20 GENERIC ISSUES

In this chapter, the staff discusses its evaluation of (1) the compliance of the Westinghouse AP600 design with 10 CFR 52.47(a)(1)(iv) and 52.47(a)(1)(ii), and (2) the incorporation of operating experience into the AP600 design. The applicant for a standard design certification is required by 10 CFR 52.47(a)(1)(iv) to propose resolutions of unresolved safety issues (USIs) and medium- and high-priority generic safety issues (GSIs) defined in NUREG-0933, "A Prioritization of Generic Safety Issues," that are (1) technically relevant to the design and (2) identified in the applicable supplement to NUREG-0933. In addition, the applicant is required under 10 CFR 52.47(a)(1)(ii) to propose resolutions to the technically relevant portions of Three Mile Island (TMI) Action Plan items addressed in 10 CFR 50.34(f).

By letter dated June 26, 1992, Westinghouse made its application for standard design certification (SDC) of the AP600 standardized plant design in accordance with the provisions of 10 CFR 52.45. The design is described in the AP600 Standard Safety Analysis Report (SSAR) from Westinghouse. Therefore, the applicable date for the appropriate supplement of NUREG-093

Figure 21.6-1
 AP600 Peak Cladding Temperature Transient for the AP600 $C_D = 0.8$ DECLG Break

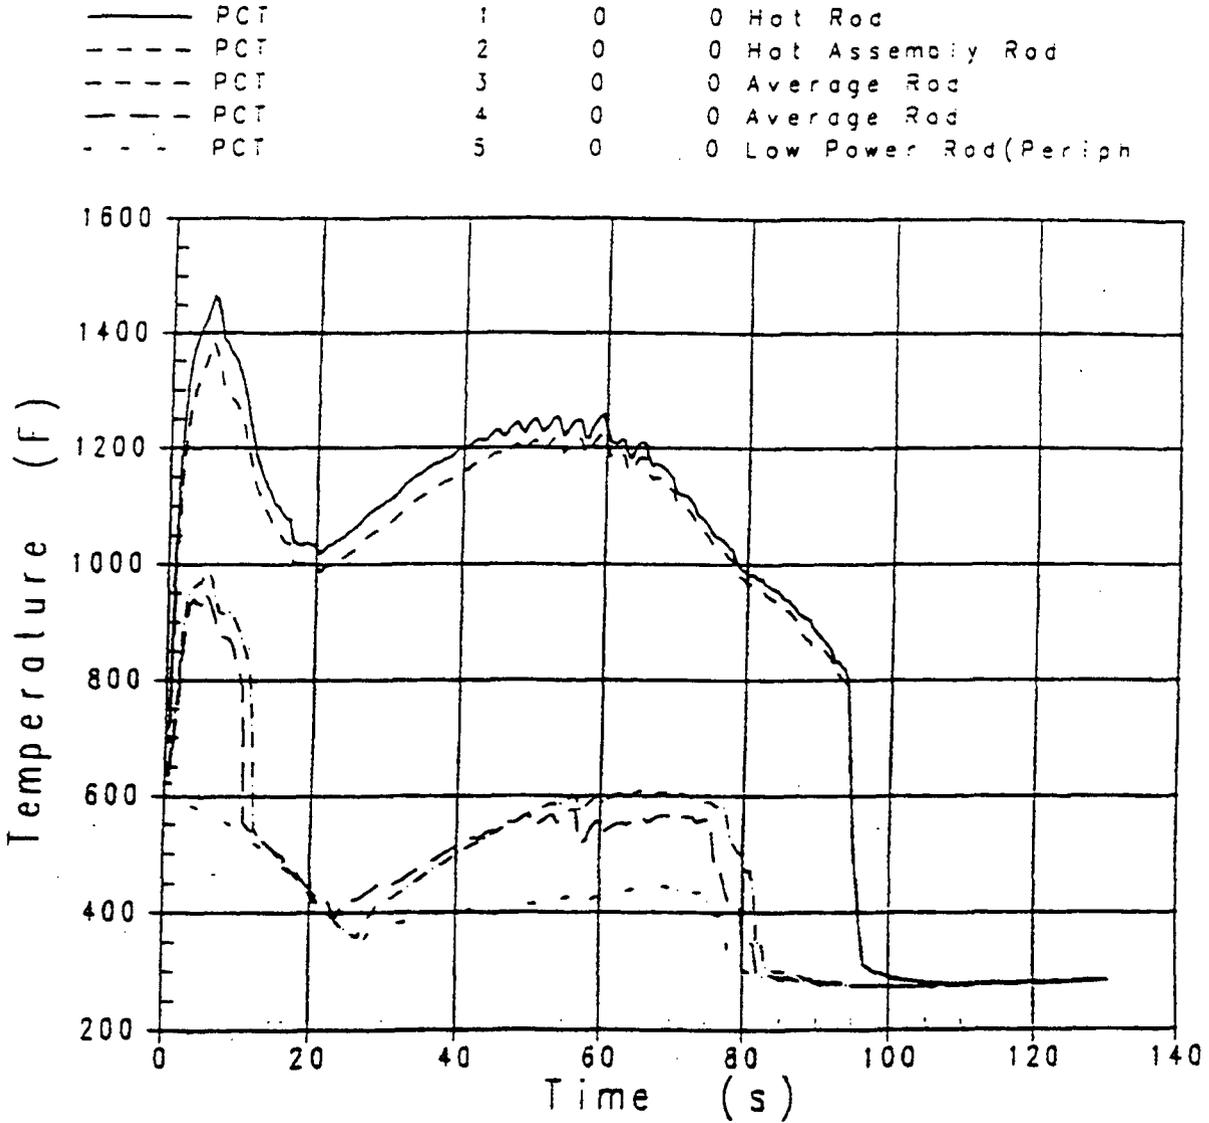
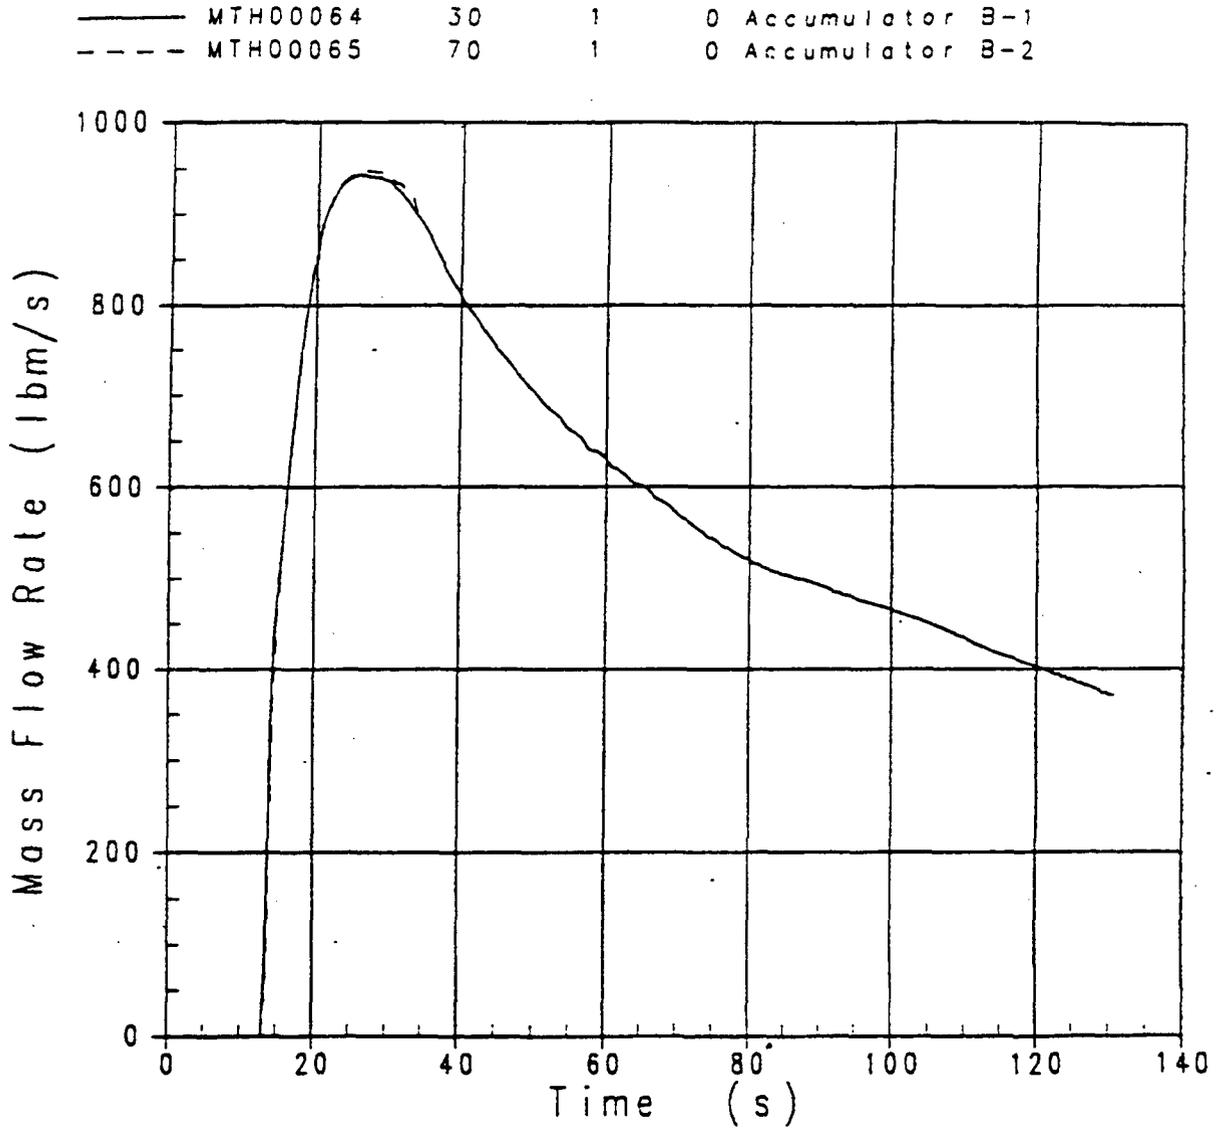
For AP600, accumulator nitrogen cover gas is not important because the AP600 accumulators do not empty until after the core is completely quenched (see Figures 21.6-1 and 21.6-2 of this report). In addition, on the basis of the Westinghouse response to comment 1(g) in letter NSD-NRC-97-5171, dated June 10, 1997, there is 60 percent of the initial liquid remaining in the accumulators at the time of PCT so that small changes in the analysis results or the AP600 design will not cause the accumulators to empty before the time of PCT. In the approved methodology, Westinghouse results presented in response to Volume 1, Question 134, of its

Figure 21.6-3
CCTF Run 58, Medium-Powered Rod, Clad Temperature Comparison at 6 ft

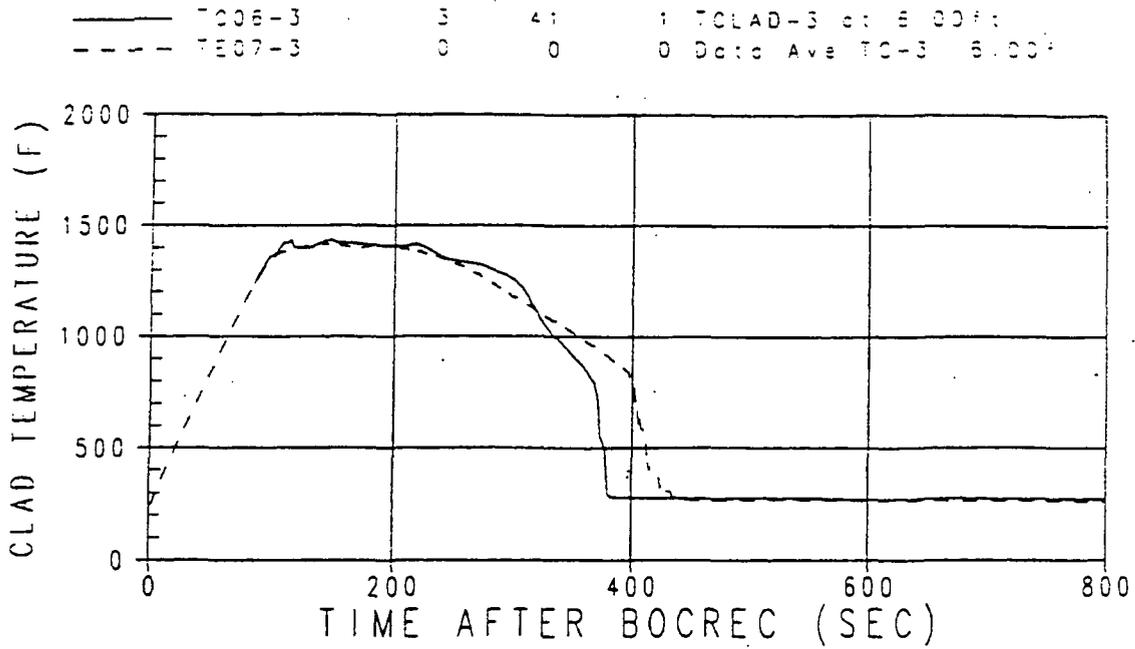
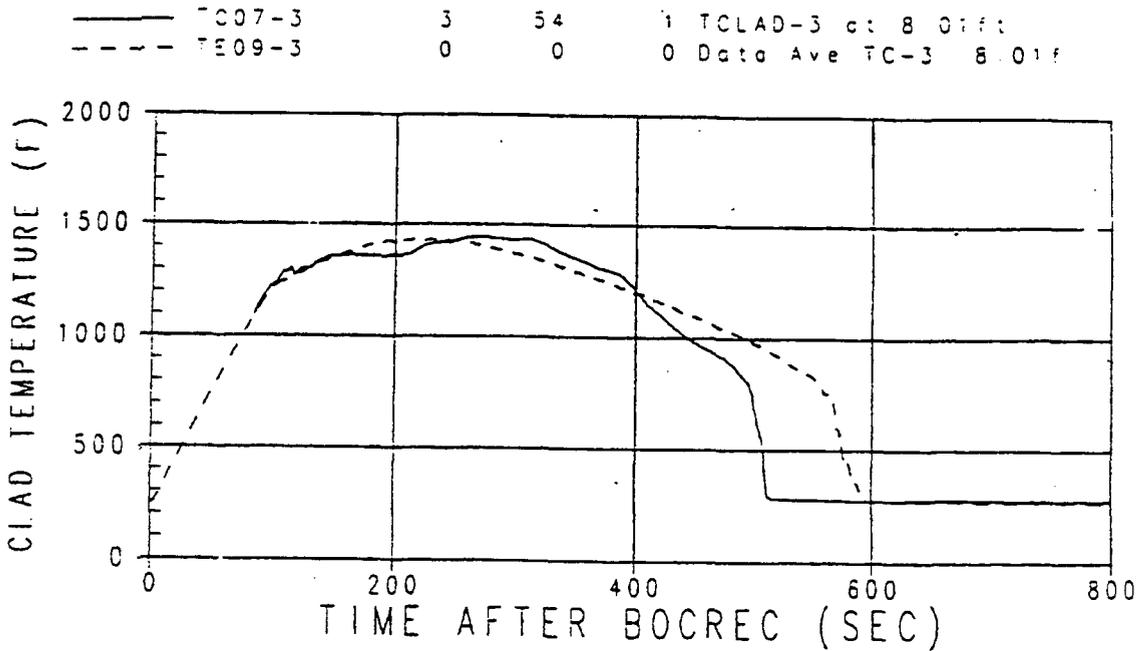
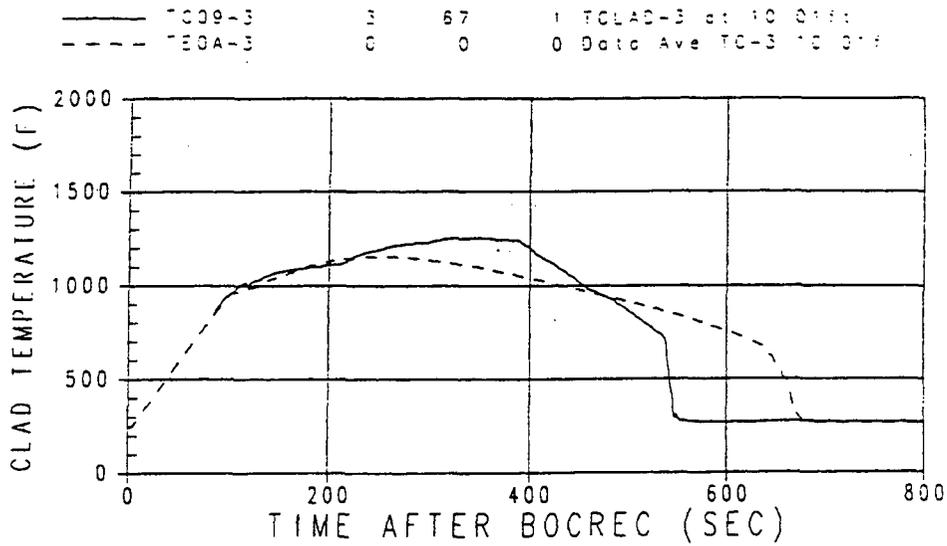
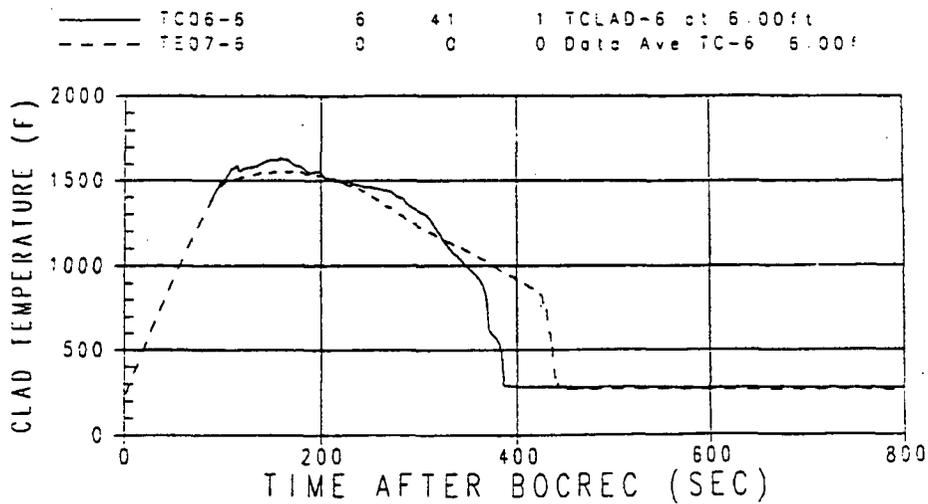
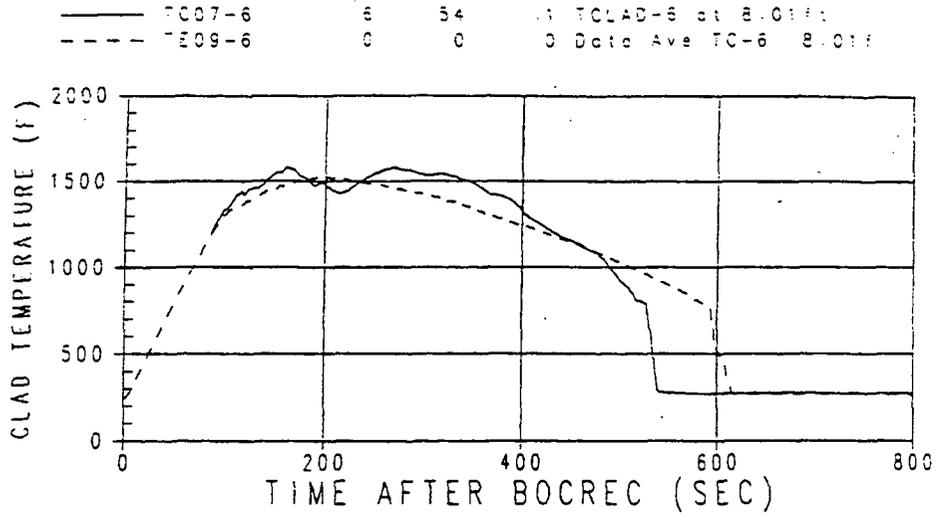
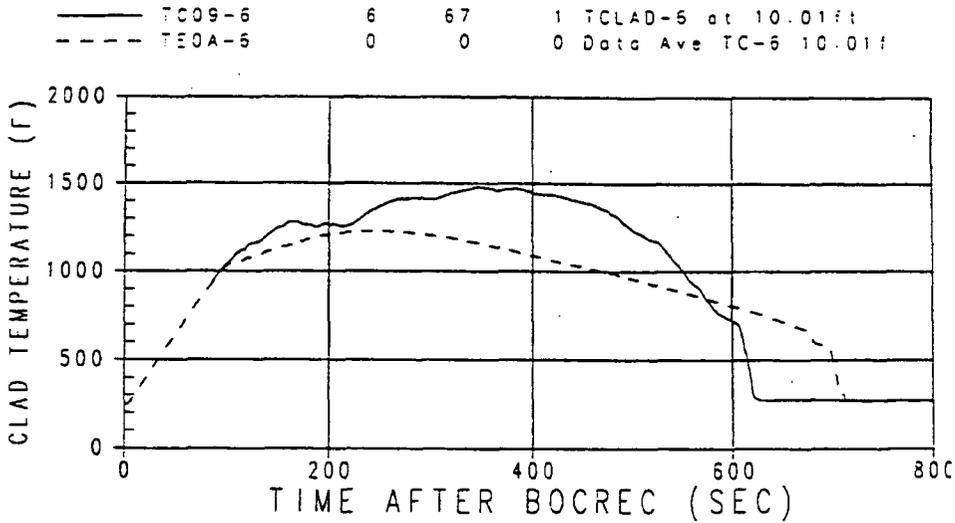
Westinghouse compared the calculated and measured results for a number of parameters. The cladding temperature response is illustrated in Figures 21.6-3 to 21.6-8. All the comparisons of cladding temperature response are found in Figures 3.1-16 to -30 of WCAP-14171-P. The comparisons showed the calculated results overpredicted the cladding temperatures with the greatest overprediction coming at the 2.4 m (8 ft) and 3 m (10 ft) elevations. While the cladding PCTs were higher, the calculated cooldown after the PCT was more rapid, and quench times were earlier than indicated by the data (Figures 21.6-9 to 21.6-11). Westinghouse attributed the more rapid quench progression in the WCOBRA/TRAC analysis relative to the data to the fact that the calculated results did not show the core/downcomer oscillations observed in the test. As discussed in the Westinghouse response to comment 8 of its July 18, 1997 letter (NSD-NRC-97-5240), this difference was because of the calculated downcomer level stabilizing below the downcomer injection port, whereas the downcomer level recovered to submerge the port in the test. The lower downcomer level was the result of a small overprediction of entrainment out of the vessel.

Figure 21.6-12
CCTF Run 58, Upper Plenum Pressure Comparison

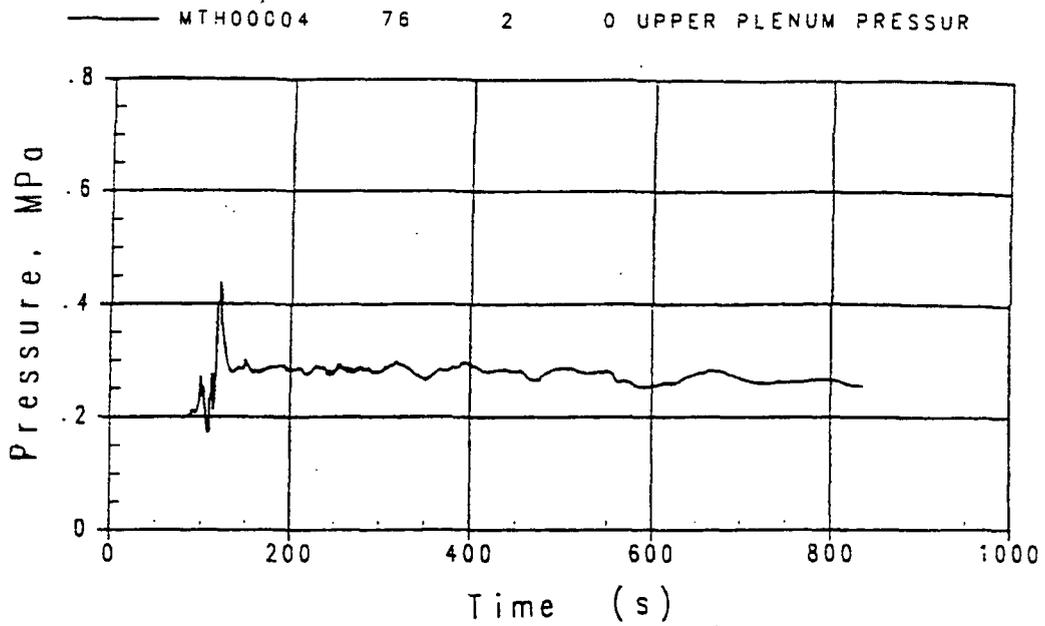
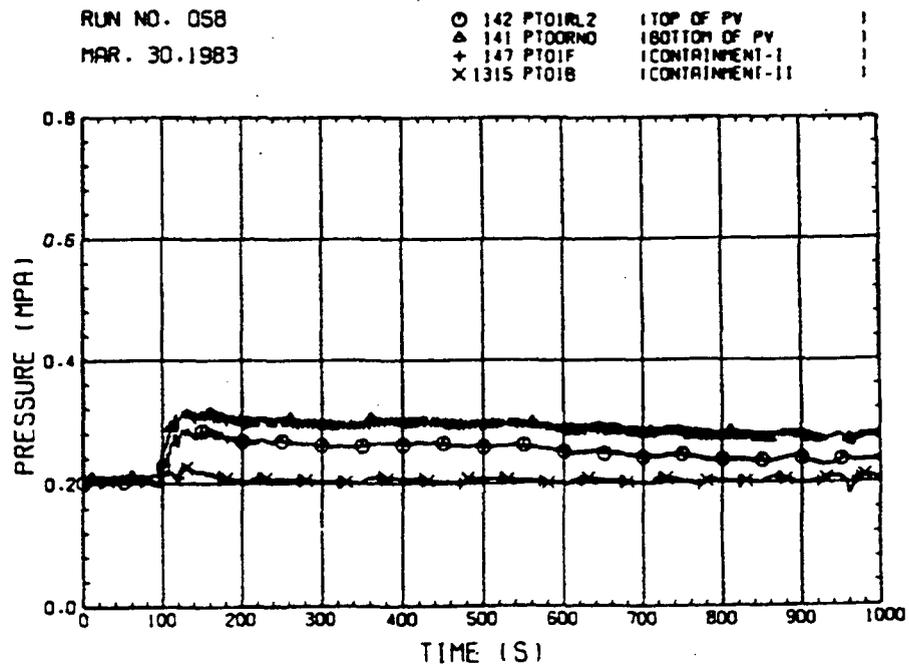
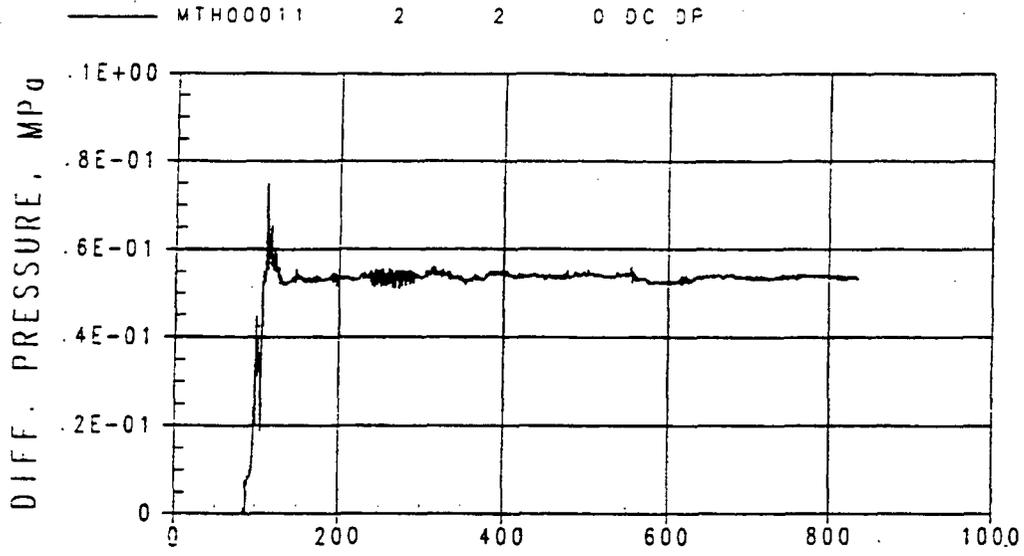
The upper plenum pressure is overpredicted for most of the test (Figure 21.6-12) because the more rapid quench advancement in the calculation results in higher steam production relative to the test. Downcomer and core differential pressure comparisons (Figures 21.6-13 and 21.6-14, respectively) show that the calculated downcomer pressure difference was within the band of the oscillations observed in the test, and the measured core pressure difference was well predicted. Regarding loop flows, the comparisons show that in general WCOBRA/TRAC results were relatively close to the test data except for the Cold Leg 1 and Hot Leg 4 steam mass flows, which were overpredicted (Figures 21.6-15 to 21.6-19).

Figure 21.6-13
 CCTF Run 58, Downcomer Differential Pressure Comparison

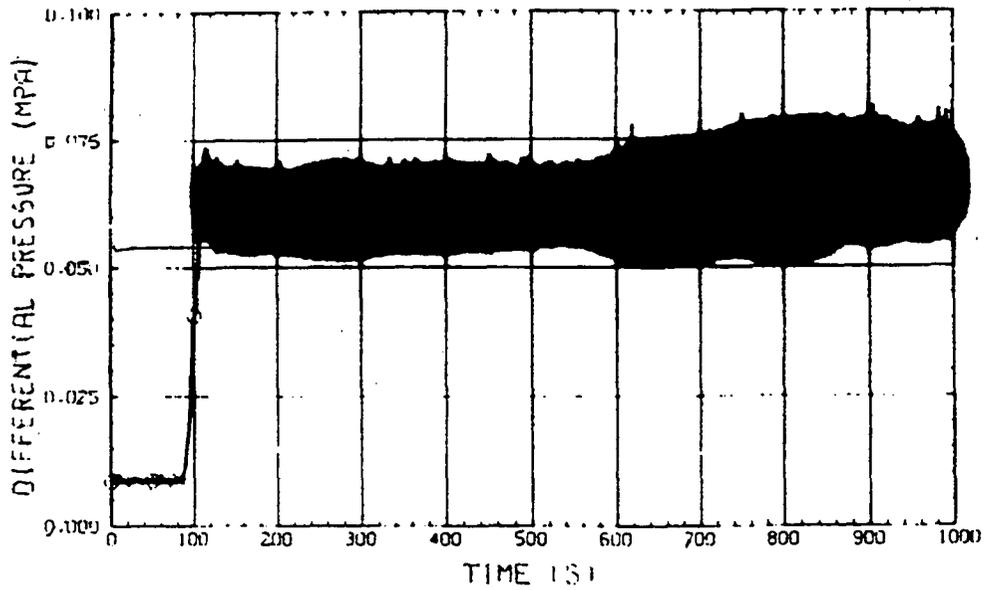
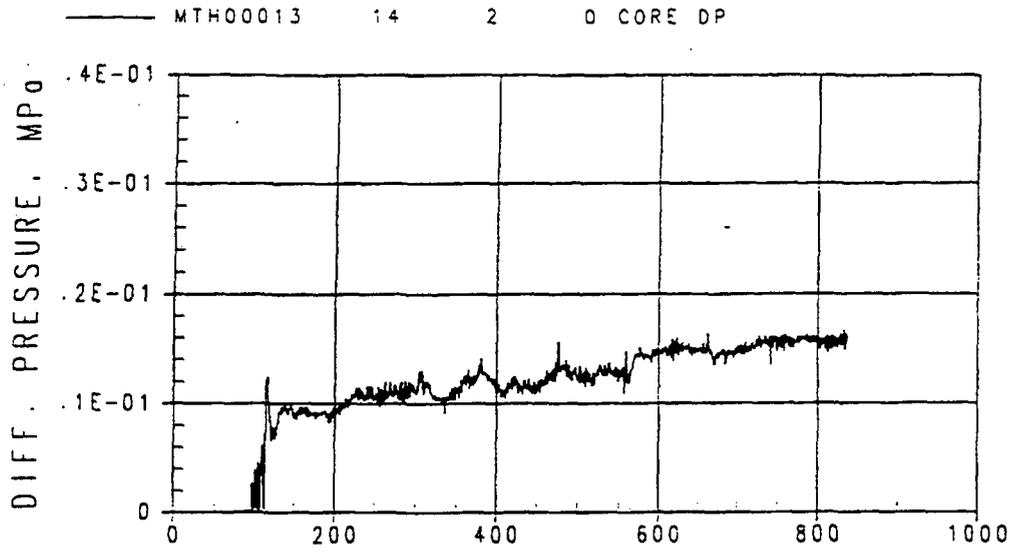
In the response to comment 7(f) in its letter NSD-NRC-97-5171, dated June 10, 1997, Westinghouse noted the core and downcomer differential pressures were calculated well as shown in Figure 3.1-35 and Figure 3.1-36 of WCAP-14171-P. On review of those figures, it was found that the calculated downcomer differential pressure was within the band of the oscillations observed in the test and the measured core differential pressure was well predicted. Therefore, this item is closed.
